Edit: R4 is now in parallel, the +3.3V on the right of L1 is now +3.3VA and added +5v to the VBUS.

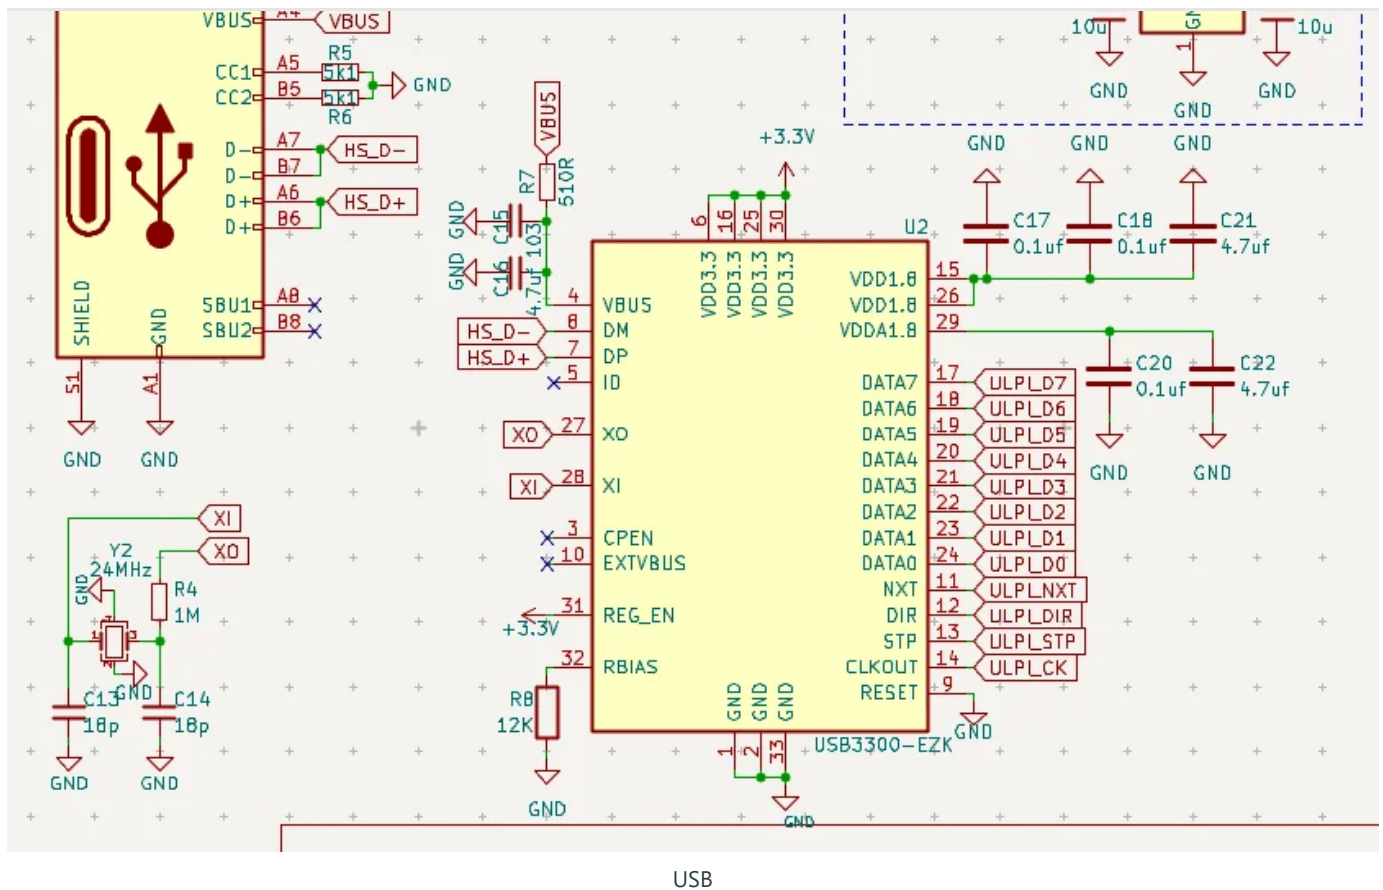
R4 (1Meg resistor) should be across XI and XO, not inline.

I did not see any other +5V power label, other than on the regulator input. I am guessing this should be connected to VBUS.

L1 is useless as it has the same +3.3V net on both sides.

For beautification, please draw the GND power label only downward pointing, makes a much more readable schematic.

L1 is shorted btw. I assume the right side should say +3.3VA instead of just +3.3V?

You know there are crystals that don't need the extra components

2. 1M resistor should be across the crystal not in-line
3. Where does +5V come from?

Yes, I had another look and it is right that they should be in parallel.

I've added one now.

Silly of me to have overlooked the fact that it should be a +3.3VA instead of a +3.3V on the right.

Correct. I have changed it now. Thank you for your reaction.
